Re: McGuire Nuclear Station
Docket Nos. 50-369

Attached is a proposed change to the McGuire - Unit 1 Technical Specifications concerning the minimum measured Reactor Coolant System flowrate. This item has been reviewed and it has been determined that there are no adverse safety or environmental impacts associated with the proposed change.

Technical Specification 3/4.2.3 - RCS Flowrate and Nuclear Enthalpy Rise Hot Channel Factor

Proposed Change

FIGURE 3.2.3 RCS TOTAL FLOWRATE VERSUS R_1 AND R_2 —FOUR LOOPS IN OPERATION

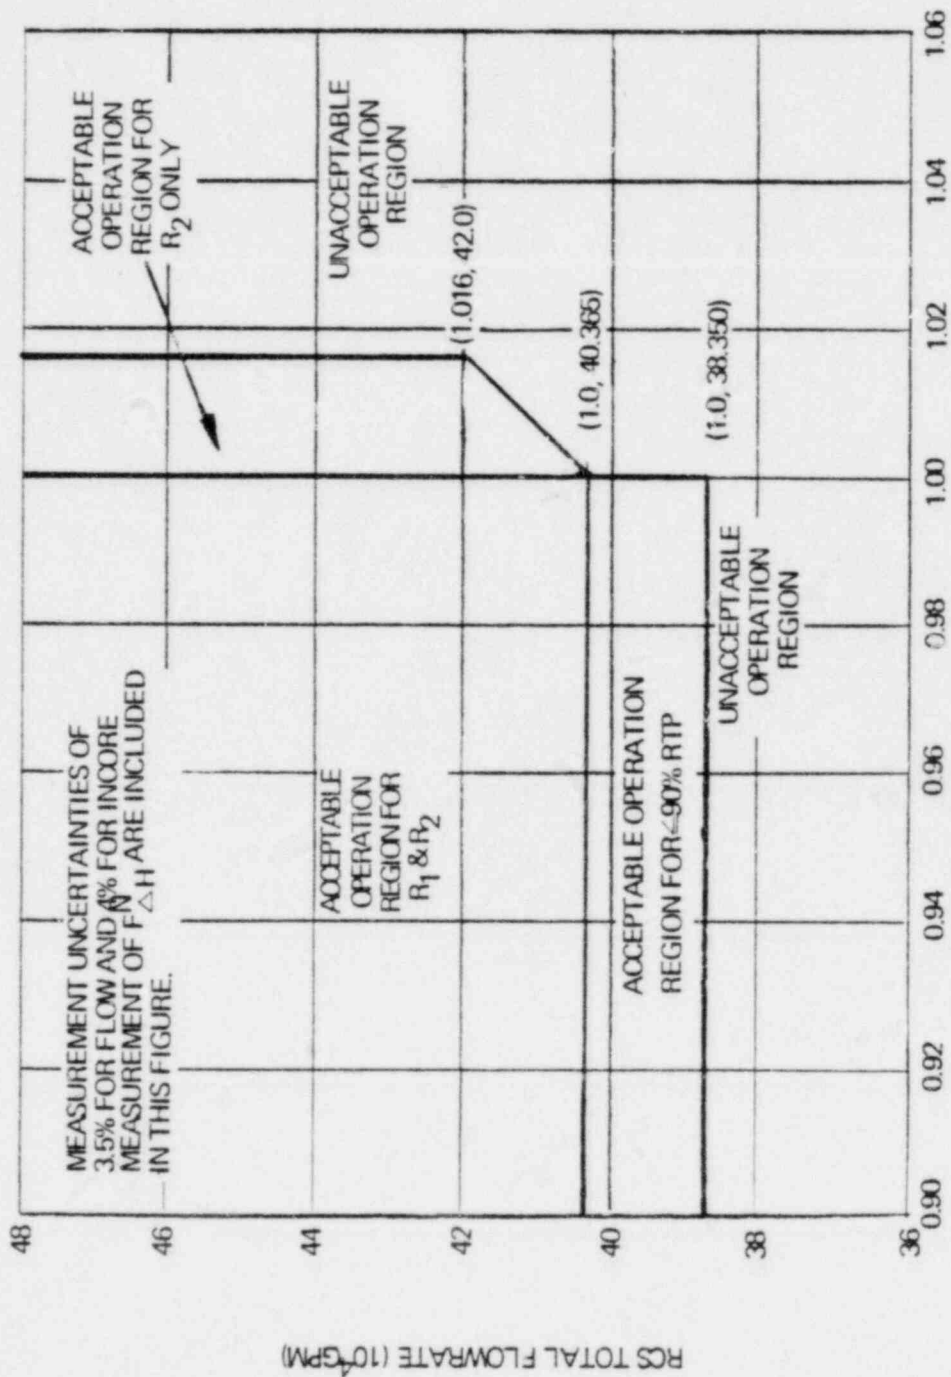
Revise Figure 3.2-3 to lower the minimum Reactor Coolant System flowrate to 383,500 gpm for operation at or below 90% Rated Thermal Power. This value corresponds to 95% of thermal design flow plus measurement uncertainties of 3.5%.
